SWAG 81 93 2682

to fit:

Water pump

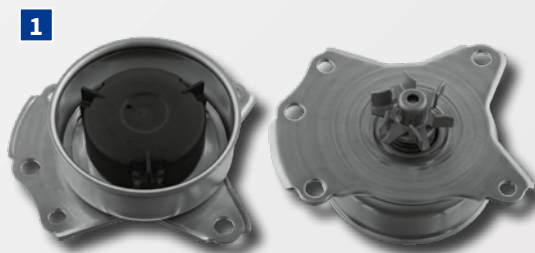
The water pump leaks.

The water pump fitted by the vehicle manufacturer can leak, because the material used is perforated steel sheet (1). In the worst case, this can lead to significant engine damage.

SWAG recommends using water pump SWAG no. 81 93 2682. This modified version of the water pump is manufactured from aluminium die casting. This makes the pump significantly stronger, and prevents leakage. Additionally, SWAG supplies water pump 81 93 2682 including the required gasket and suitable bolt set (2).

When fitting the new version SWAG 81 93 2682, please use bolts supplied with water pump. Torque setting for bolts is 28 Nm. The vehicle manufacturer's specifications should always be followed!
